**DOCUMENT NO:** OP-1903.010

**TITLE:** EMERGENCY ACTION LEVEL CLASSIFICATION

**CHANGE NO:** PC-04

**ENTERGY OPERATIONS INCORPORATED  
ARKANSAS NUCLEAR ONE**

ATTACHMENT 5  
UNIT 1

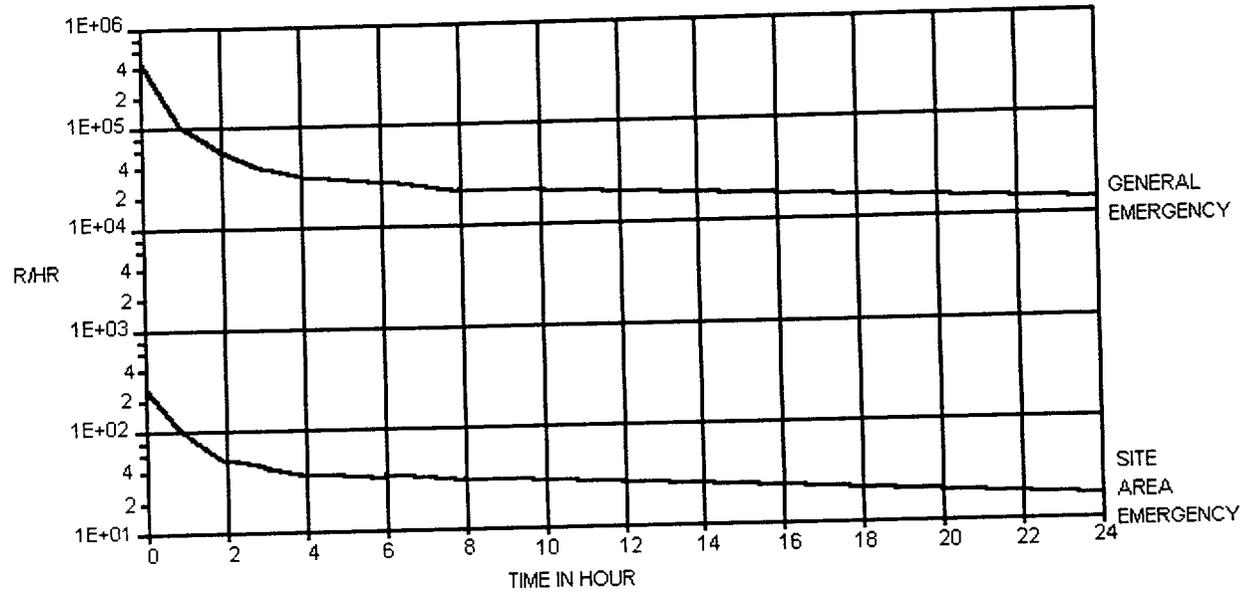
Added note to clarify the differences in the failed fuel graphs in 1903.010 and 1903.011.

NOTE:  
This graph corresponds with 1903.011 Attachment 7 (WITH Spray), SAE equals 1% Clad Failure and GE equals 50% Fuel Overheat.

ATTACHMENT 6  
UNIT 2

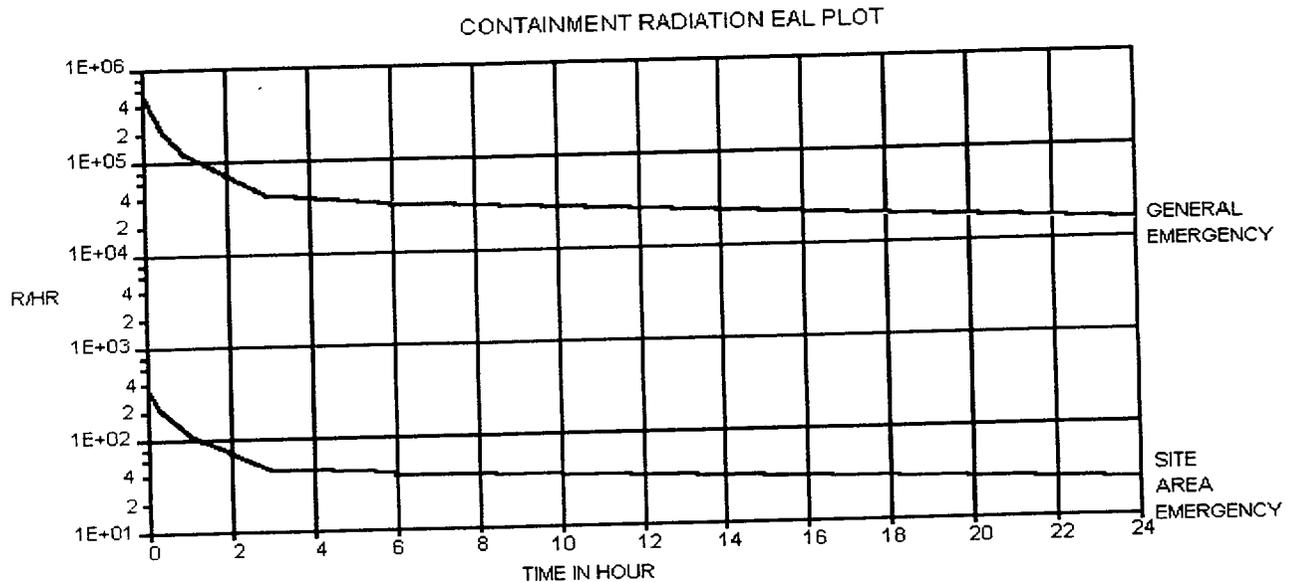
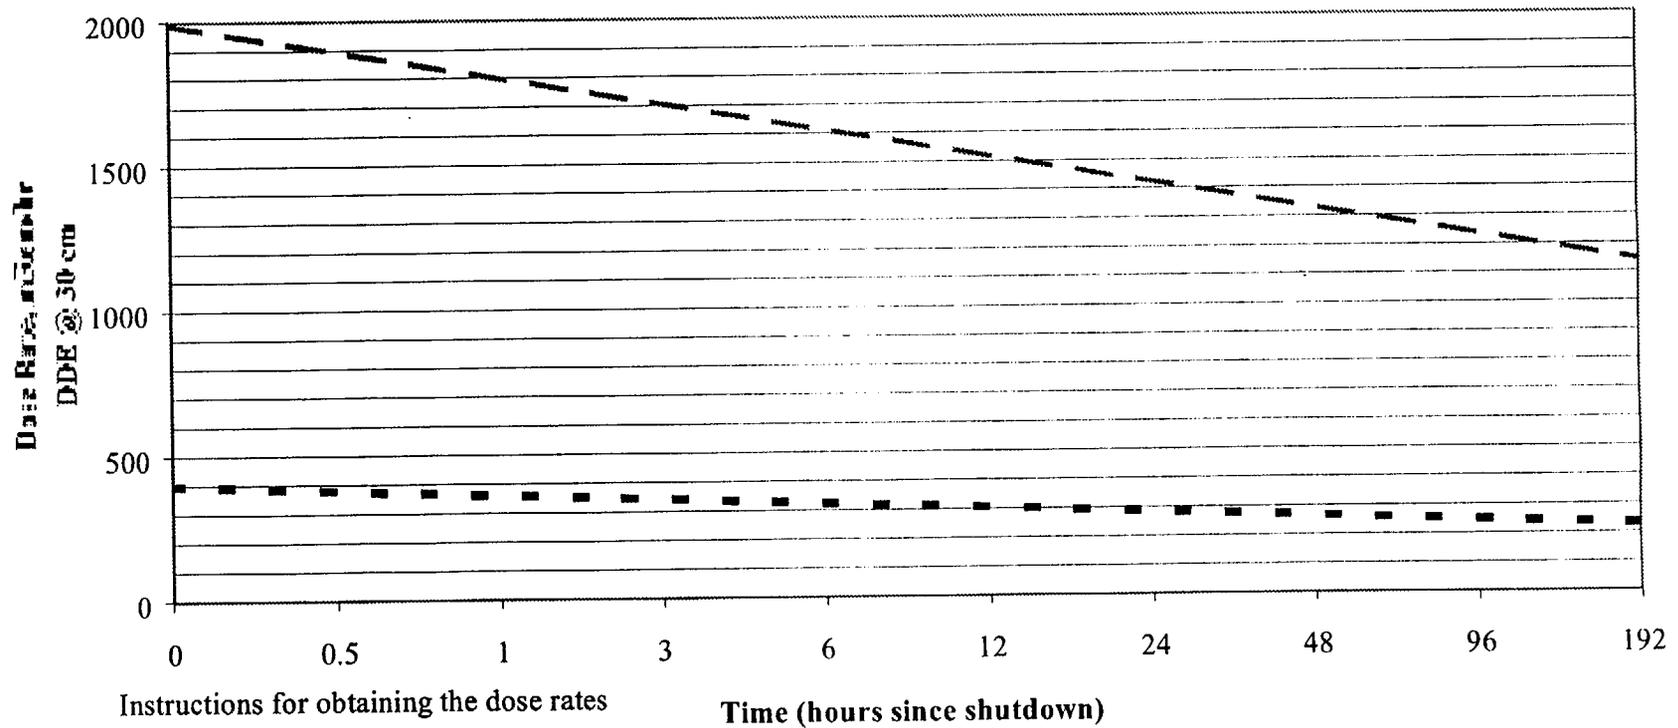
Added note to clarify the differences in the failed fuel graphs in 1903.010 and 1903.011.

NOTE:  
This graph corresponds with 1903.011 Attachment 8 (WITH Spray), SAE equals 1% Clad Failure and GE equals 50% Fuel Overheat.
